**TECHNICAL SERVICE BULLETIN, VIN:
WSB-05 Open Trail Active Radar Cruise Control Sensor Correction**

Technical Service Bulletin WSB-05 Repair Instructions

Purpose: Replace front active radar cruise control bracket to correct sensor orientation.

Models: 2026 Open Trail Motorhomes

Figure 2

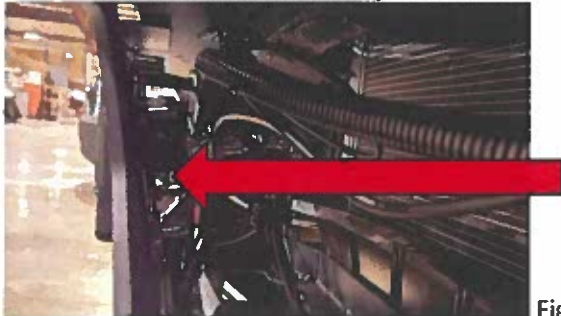
1. Remove the radar bracket from bumper housing by removing the three bolts that fasten the bracket and sensor to the bumper housing using 3/16" Allen wrench and a 7/16" box end wrench for the nuts. See figure 2. **NOTE:** Keep bolts for reinstalling new bracket.

Figure 3

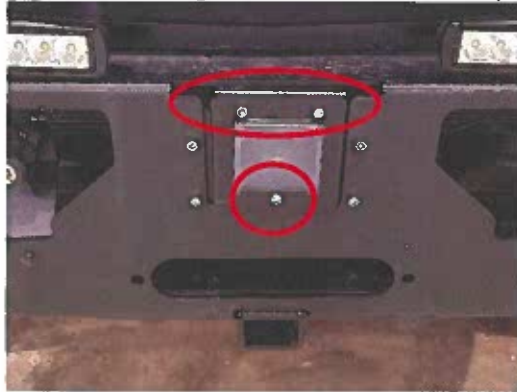
2. Remove the radar sensor from the radar bracket by locating and then removing the 3 bolts, using 3/16" Allen wrench and a 7/16" box end wrench for the nuts. **NOTE:** Keep bolts for reinstalling new bracket.
3. Install the radar sensor into the new bracket, lining the three-hole pattern up with the hole pattern on the new bracket. Use the bolts previously removed in step 2 to secure the sensor to the bracket and tighten all bolts to 25-in. lbs.
4. Install the radar bracket back to the bumper housing, making sure to orient the radar sensor as shown below in figure 3. Reinstall using the bolts removed in step 1 and tighten to 25 in. lbs.

Figure 4

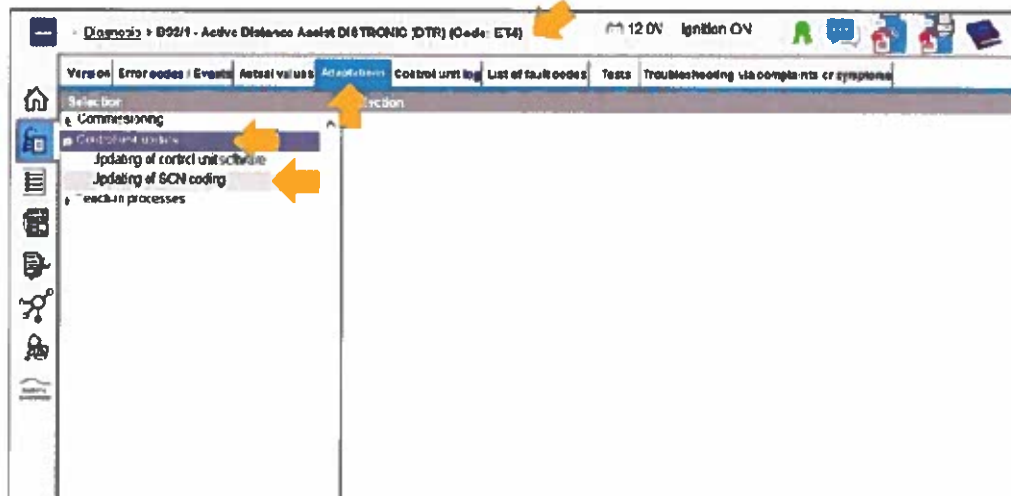
5. At a Mercedes Benz certified service center, properly program the chassis to ensure proper re-calibration of the active radar cruise control. **NOTE:** If needed, please see Xentry B92/! Commission, see Figure 4.

SCN code Active Brake Assist – B92 or Distronic – B92/1
